STATEMENT TO AMEND CONDITIONS APPLYING TO A PROPOSAL
(PURSUANT TO THE PROVISIONS OF SECTION 46 OF THE
ENVIRONMENTAL PROTECTION ACT 1986)

YANDICOOGINA IRON ORE MINE & RAILWAY
90 KILOMETRES NORTH-WEST OF NEWMAN
HAMERSLEY RANGE

Attachment to Statement 523, change to definition of proposal

Change to Proposal

Figure 2. Layout map

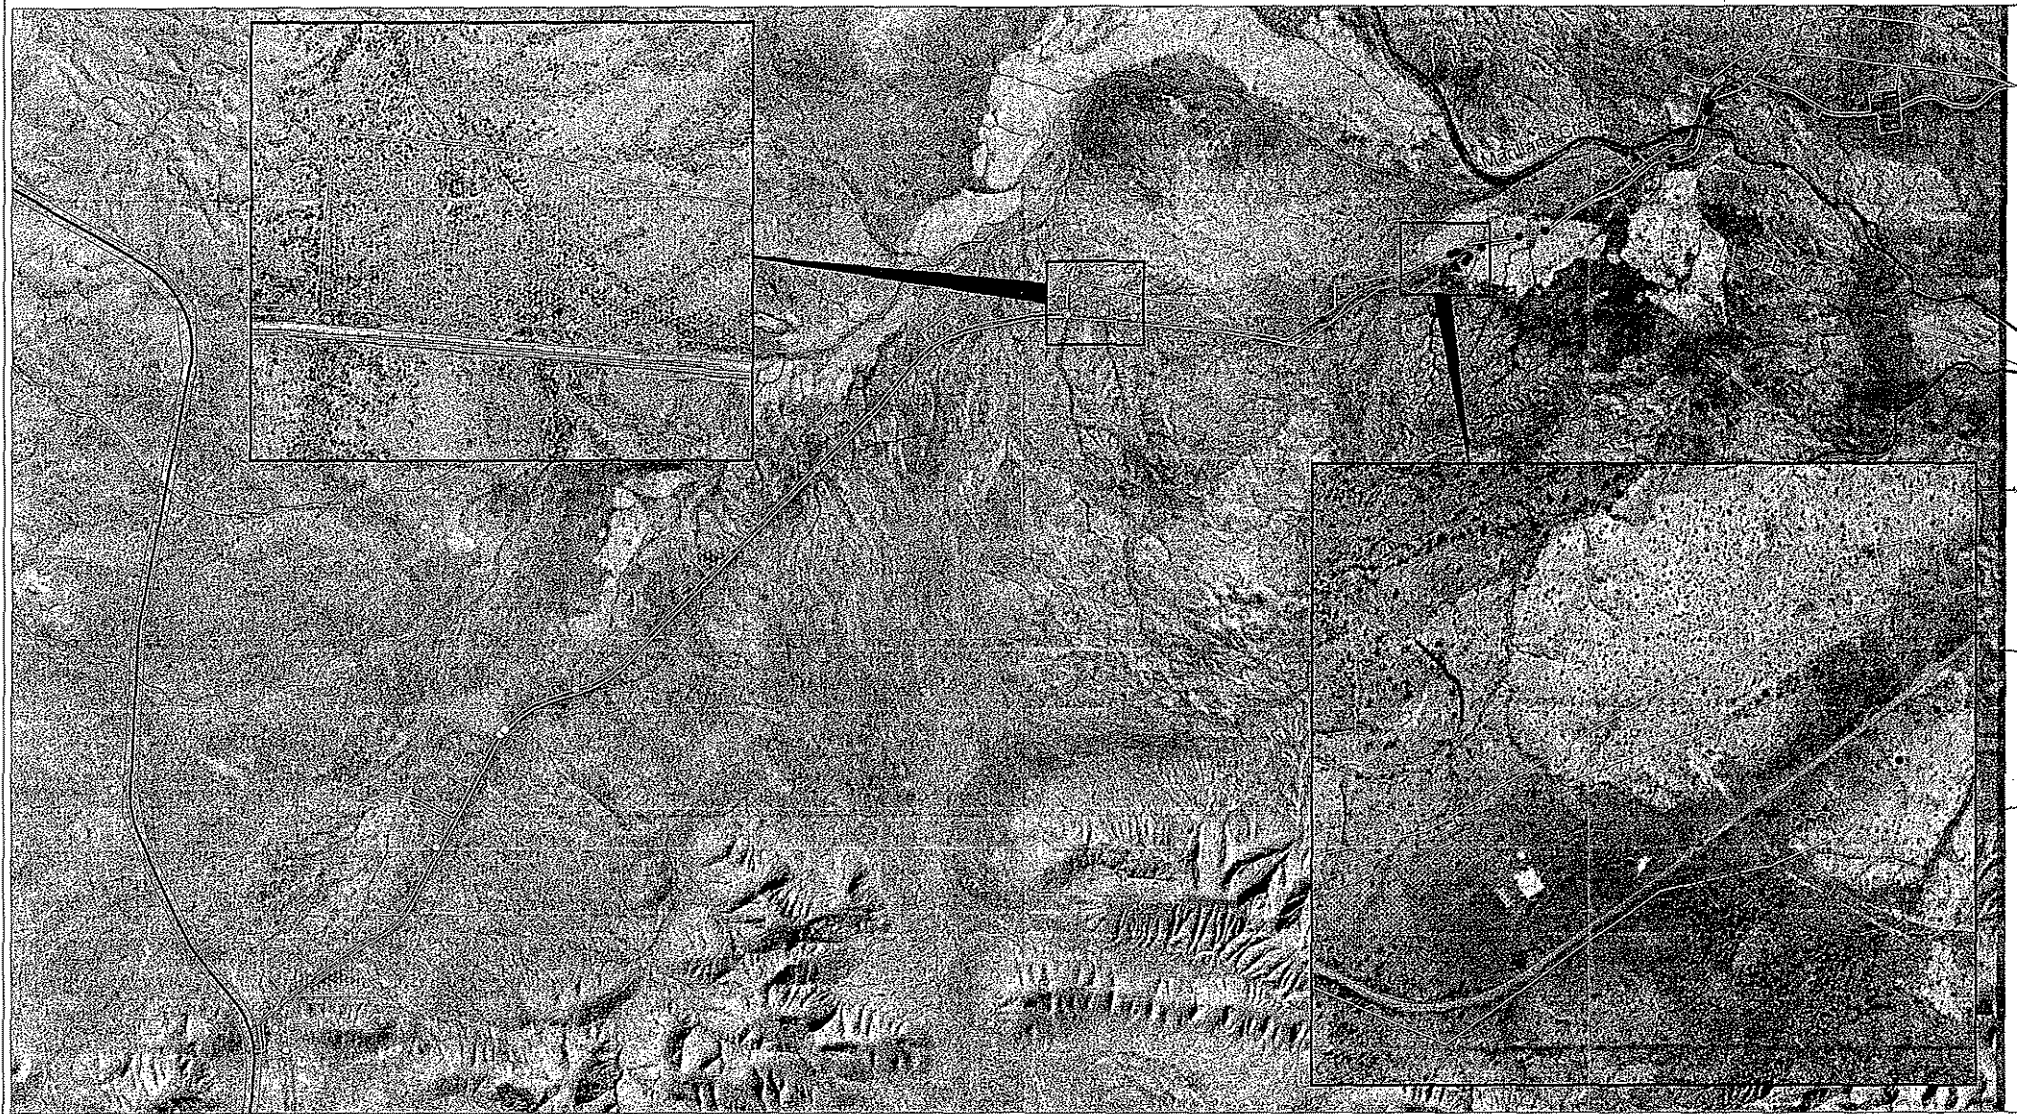
Change: to the description in the Consultative Environmental Review for Statement for 417 and to Schedule 1 of Statement 523.

From:

Element	Quantities/Description
Access Road	Unsealed road 27km long linking Great Northern Hwy and western boundary of BHPB's mining lease 70/270

To:

Element	Quantities/Description
Access Road	Sealed road with minor deviations, new floodway crossing at Marillana Creek, and other improvements

Figure 2a

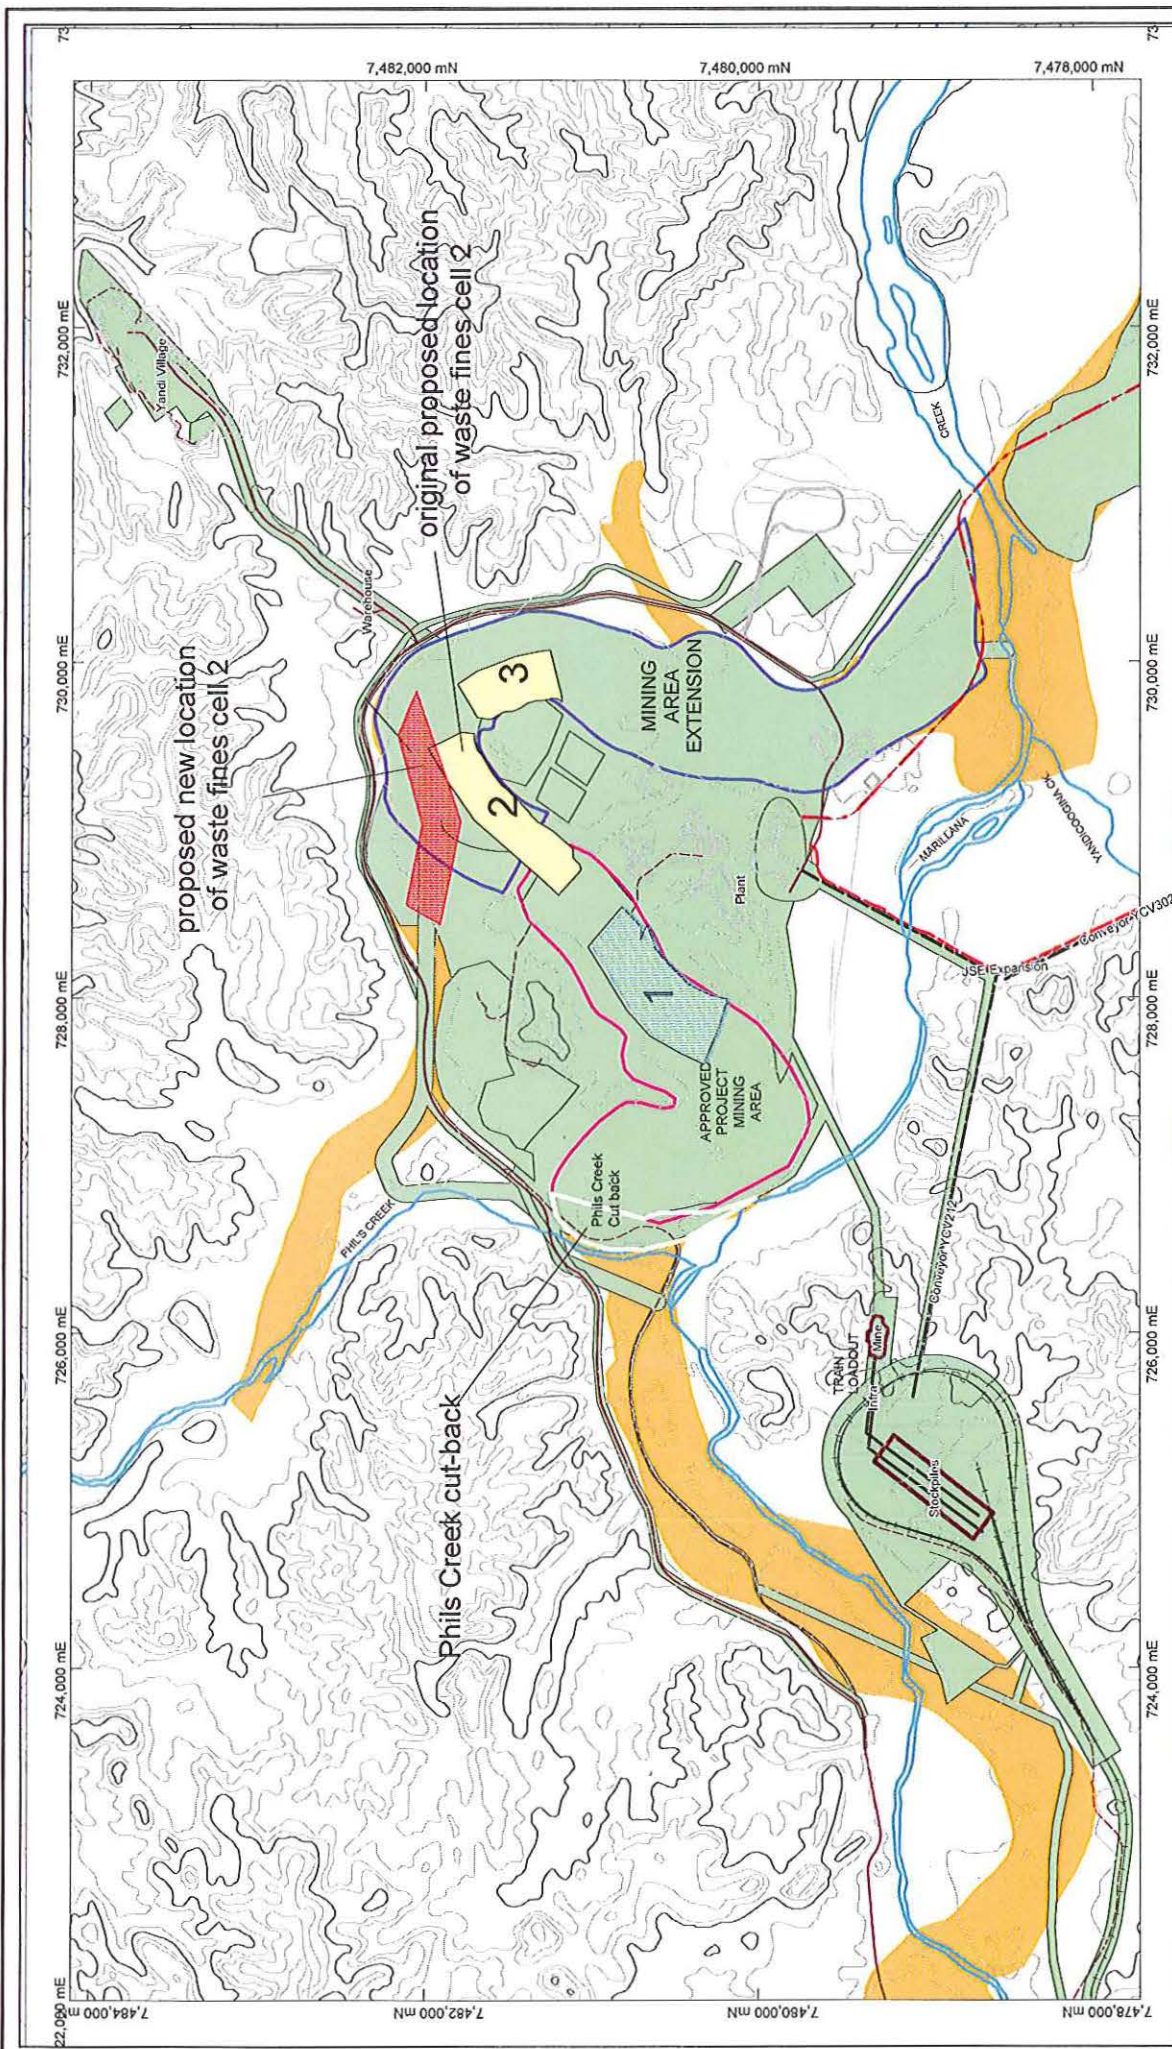
Change: To develop a new pit cutback near Phil's Creek, and to relocate the position of an approved Junction Central waste fines cell (see attached figure 2a).

Updated Figure 2a:

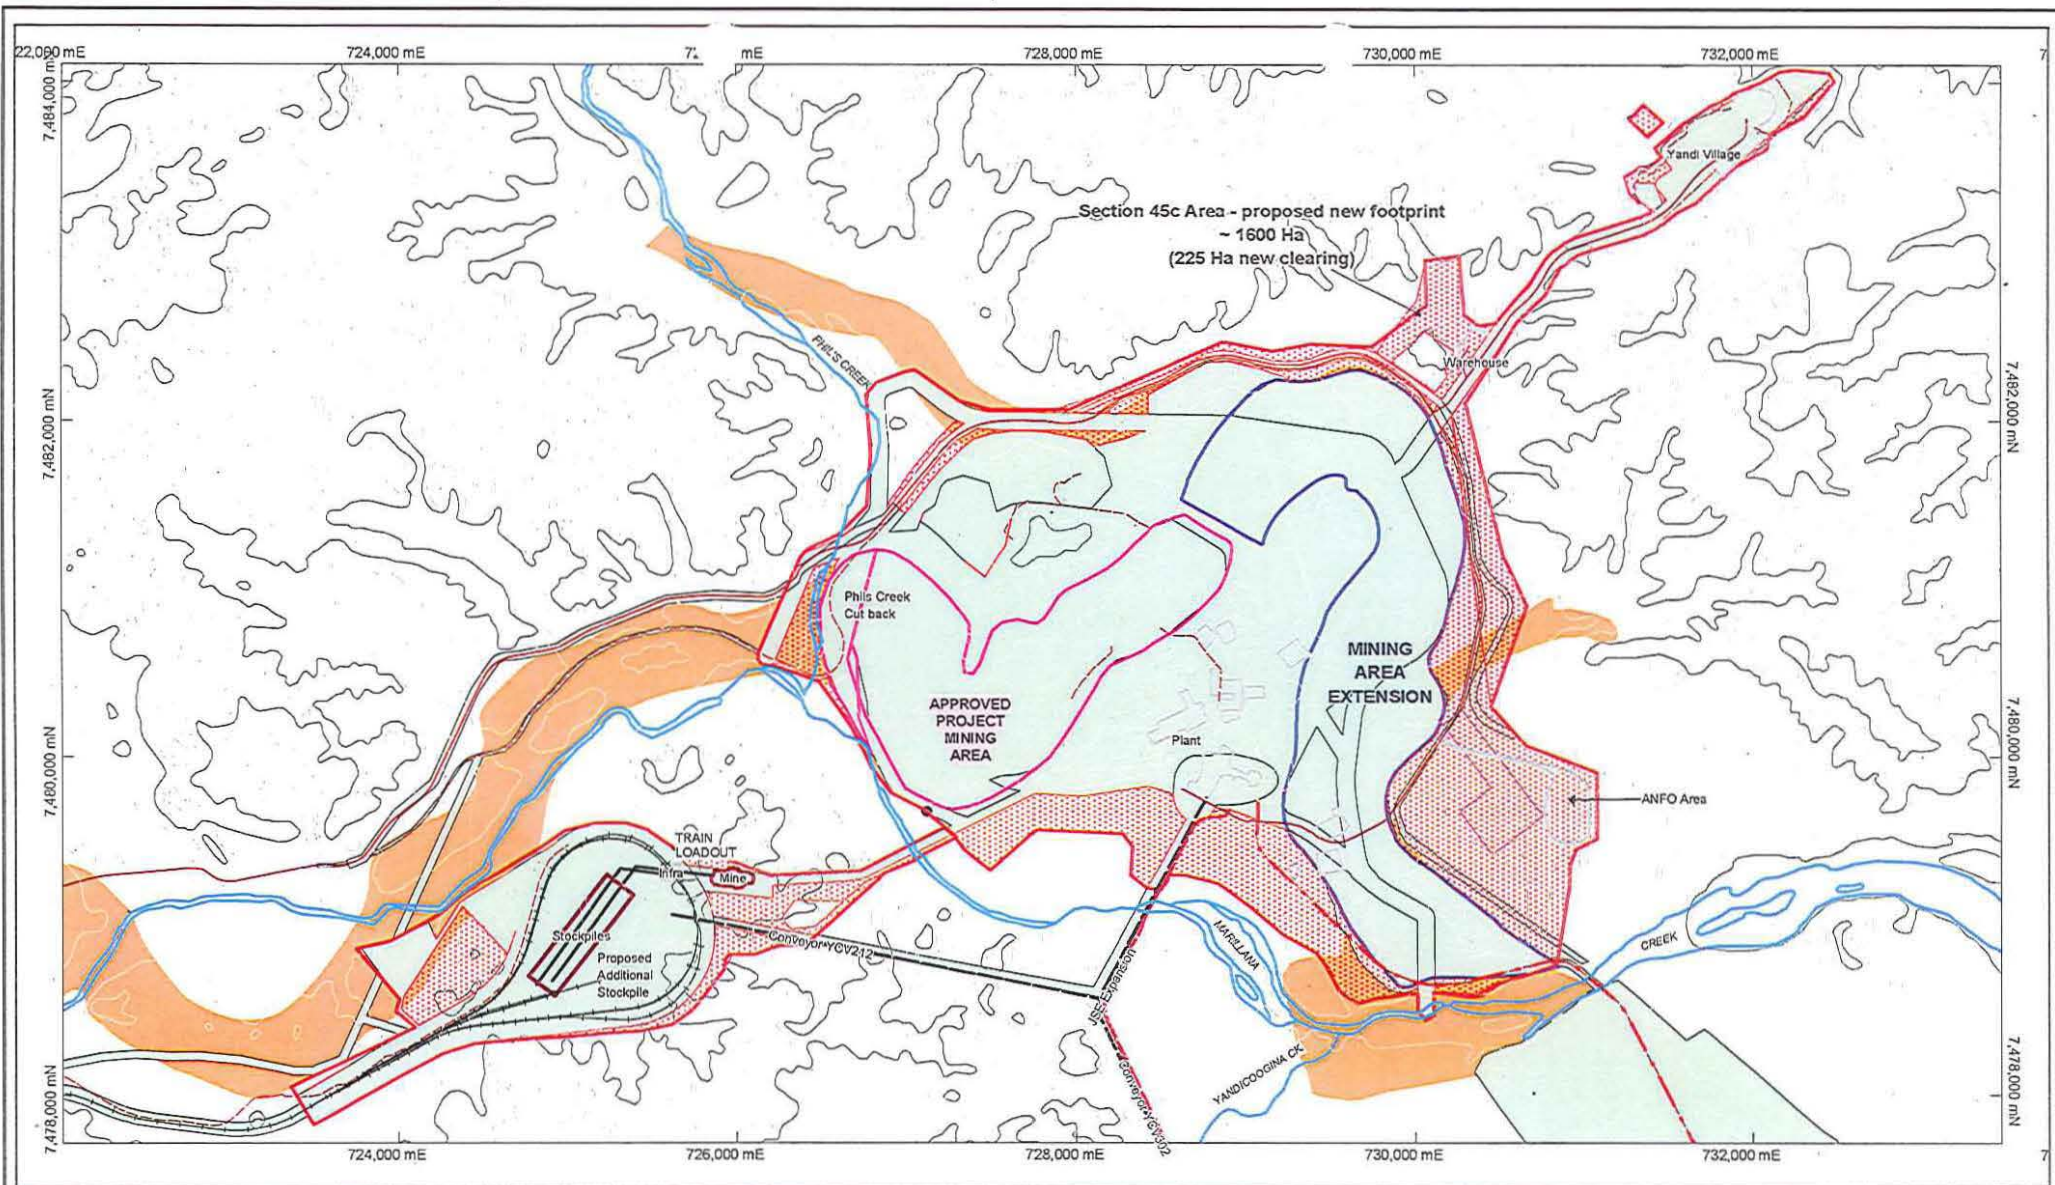
Change: Increase site footprint by 225ha, additional ore stockpiles and infrastructure, update footprint for site and raise mining rate to 36Mt/a.
